# SERVICE BULLETIN

## REPLACEMENT OF PIN PART NO. 929700 IN CARBURETOR FOR ROTAX® ENGINE TYPE 912/914 (SERIES) SB-912-048 SB-914-033

Replacement of pin part no. 929700 in carburetor for ROTAX® Engine Type 912/914 (Series)

engine  
912/914

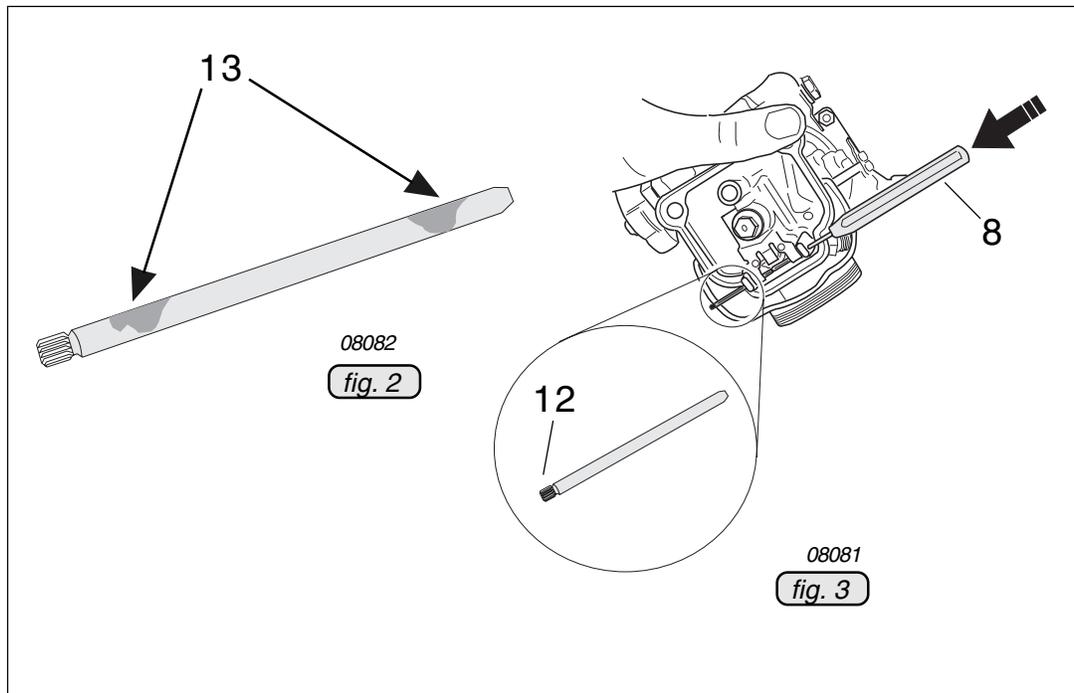
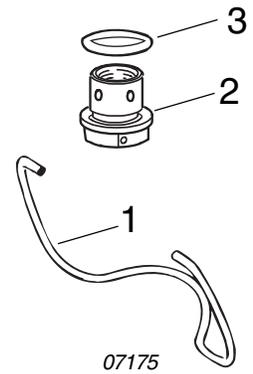
- Disconnect negative terminal of aircraft battery.
- Remove drip tray - if equipped.
- Remove carburetor.
- Open spring clip (1) or ROTAX<sup>®</sup> 914 (Series) open attachment screw (2) with o-ring (3).
- Remove float chamber (4) with gasket (5) and float (6).
- Remove pin (7) with appropriate pin punch (8) and remove float bracket (9) with float needle clip (10) and float needle valve (11)

◆ **NOTE:** The pin is serrated on one side (12). Put the pin punch on the opposite side and press out the pin. Don't damage the carb casting by pressing the serrated end through the pin support.

- Inspect the pin for flaking (13) of surface coating.
- Clean carburetor and fuel system, especially in case of flaking on the pin
- Check parts of carburetor.
- Install float bracket with float needle clip/float needle valve and the new pin part no. 929701
- Check if float suspension brackets are parallel and adjust if necessary.
- Install float chamber with gasket and float.
- Reassemble the carburetor.
- Install carburetor.
- Install drip tray - if equipped.
- Connect negative terminal of aircraft battery.
- perform basic throttle adjustment
